City of Mount Vernon
Design Review Board
Minutes – August 19, 2021

PUBLIC MEETING FOR PROPOSED FAÇADE AND SITE CHANGES TO 508 S 2ND STREET

PERMIT NUMBER:	PLAN21-0294		
PROJECT ADDRESS:	508 S 2 nd Street	PROJECT PARCEL NUMBERS:	P52080
APPLICANT:	Mark Christ		
PROJECT DESCRIPTION:	Phased project to result in 1,820 s.f. of professional office space, seven new apartments (7,946 s.f. of interior remodeling will create five (5) of the units and a 3,196 s.f. addition to the third floor will create the additional two (2) units), and new improvements including: an apartment lobby, elevator, outdoor roof deck, parking areas, dumpster enclosure, common outdoor space, and landscaping.		
APPLICABLE MVMC	MVMC CHAPTERS 17.70, 17.48, 17.84, 17.93 AND CHAPTER 14.05

Improvements to 508 2nd Street
for RPI Mount Vernon LLC

D East Elevation
1/8"=1'-0"

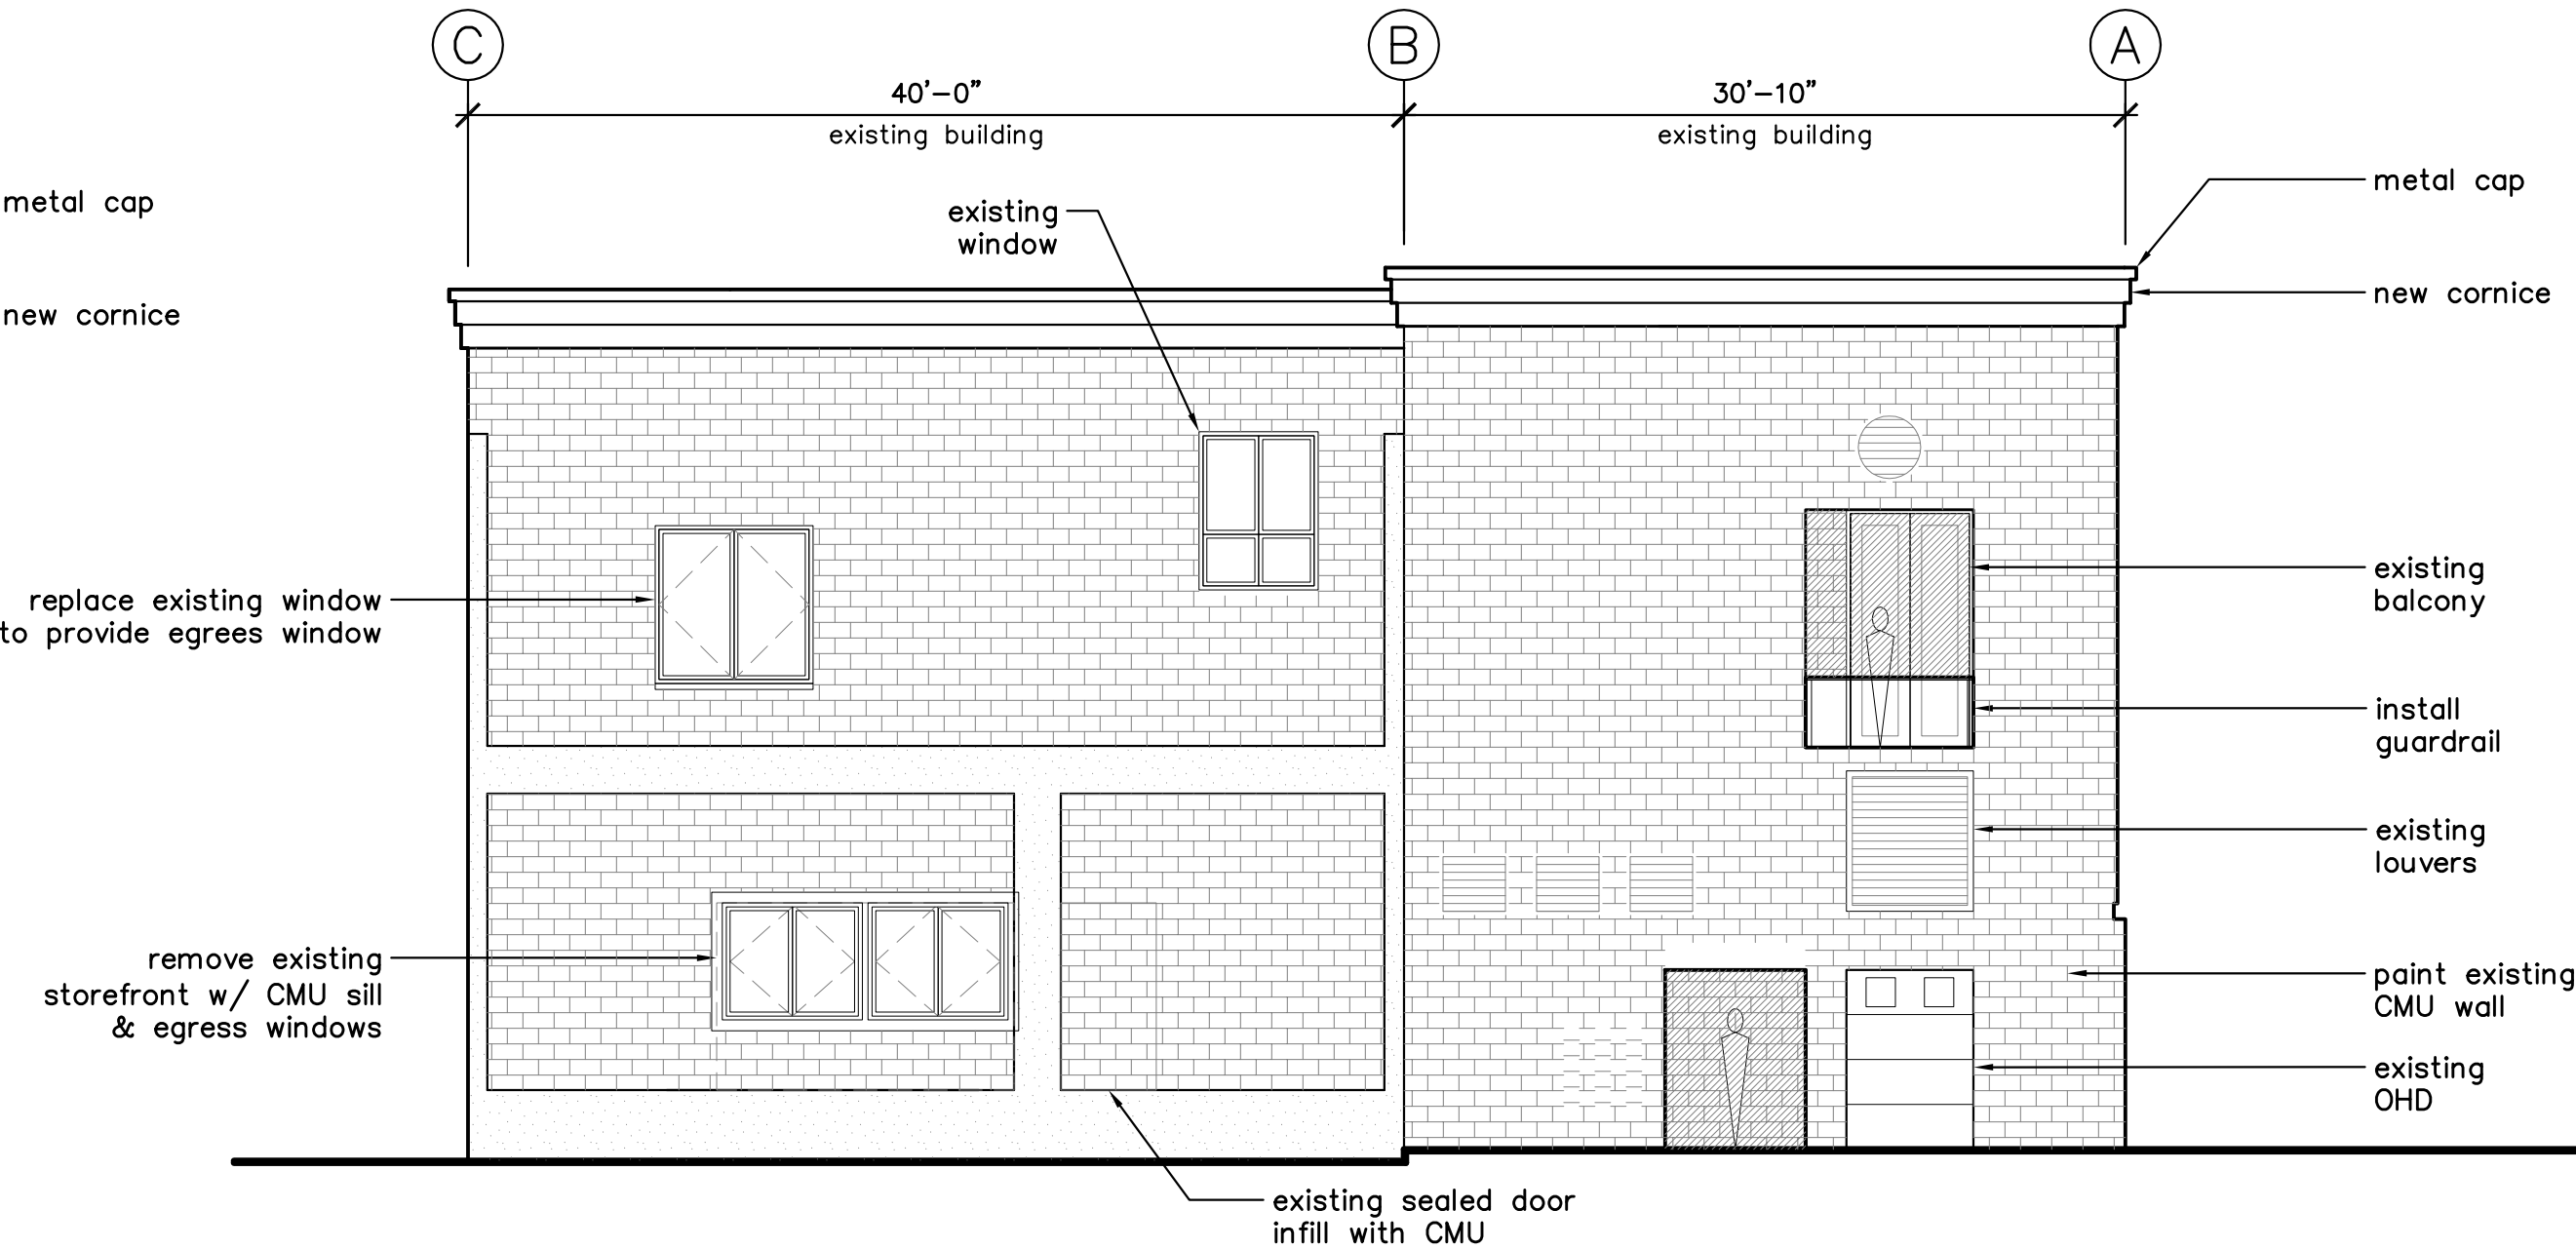
The proposed individual windows have a vertical proportion of approximately 2:1 (height to width). The Applicant will need to verify that all of the windows will be surrounded by trim, molding, sills or other architectural features and that they recess or project at least three-inches from the façade.

The Applicant will need to verify what they plan on doing to the north, east, and south facades of the structure because staff is not sure if the existing paint will be removed from the brick or not.

Staff recommends approval of a waiver for the west elevation of the structure because it is only 1.6% short of meeting the glazing requirement. Staff recommends the Applicant be required to submit revised plans bringing the north and south elevations closer to complying with the glazing requirements. Further, staff recommends the Applicant be required to submit revised drawings identifying which of the listed elements are being satisfied for 50% of more of the windows.

- b. The requirement for windows to comprise no less than 15 percent of the building façade outlined in Design Standard DT-E on the north, west, and south elevations of the structure. The Board recommends the Applicant be required to submit revised plans bringing the east elevation closer to complying with the glazing requirements. Further, the Board recommends the Applicant be required to submit revised drawings identifying which of the listed elements are being satisfied for 50% or more of the windows.

- a. Demonstrating all of the windows will be surrounded by trim, molding, sills or other architectural features and that they recess or project at least three-inches from the façade.
